Rezoning Transportation Analysis

Petition Number: 2020-055

General Location Identifier: Tax ID 04739109

Revision Log:	Date	Description
	05-18-2020	First Review

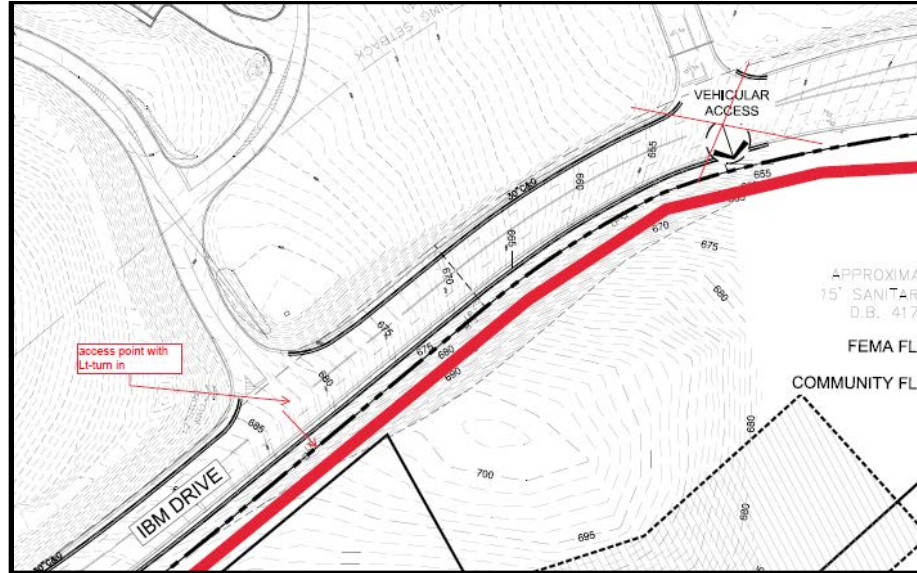
- The City ordinance gives CDOT the authority to determine driveway locations to public streets. Therefore, the petitioner should revise the site plan and conditional note(s) to commit to eliminating the northernmost proposed access point and creating an access point opposite the second Innovation Park Driveway. This comment was previously provided to the development team at a pre-submittal meeting.

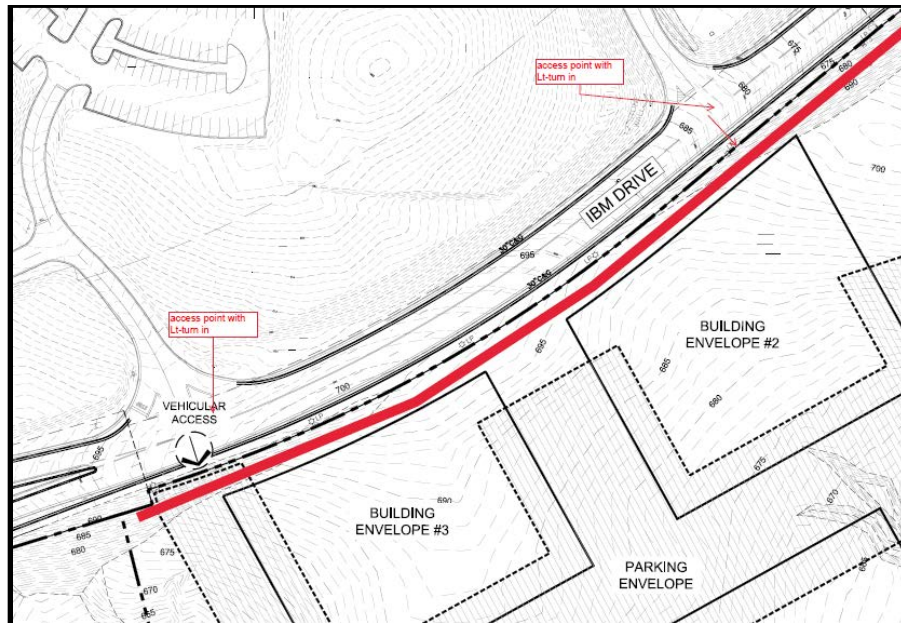
- The petitioner should revise the site plan and conditional note(s) to provide left turn lanes from IBM Drive into the site.
